World Forum for Harmonization of Vehicle Regulations

Proposal for the 03 series of amendments to Regulation No. 58 (Rear underrun protection)

Submitted by the Working Party on General Safety Provisions*

Figure 1

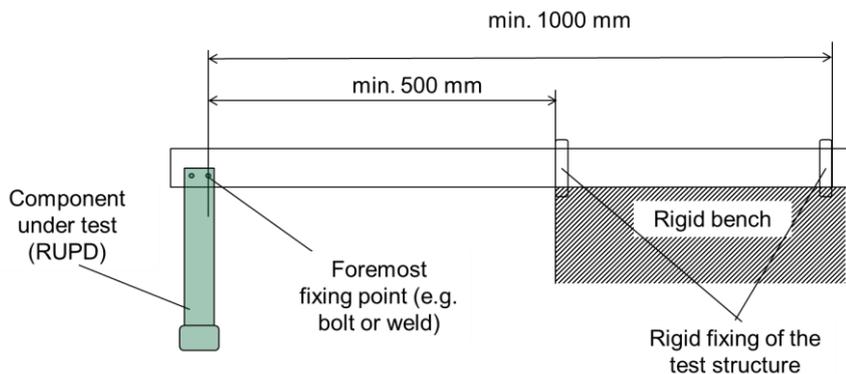
Paragraphs 1.2. and 1.3., amend to read (inserting a new Figure 1):

"1.2. In the case of paragraph 1.1.2., the parts used to connect the RUPD to part of the vehicle chassis shall be equivalent ... on the vehicle. The part of the chassis can be fixed on a test bench as shown in Figure 1, representing the minimum requirements to be fulfilled. The structures used as side rails shall be representative of the chassis of vehicles for which the underrun protection system is intended.

The distance of the foremost fixing point of the RUPD from the rigid test bench shall not be less than 500 mm. If a diagonal strut is used to support the RUPD, this distance shall be measured between the foremost fixing point of the strut to the side rail structures and the rigid test bench.
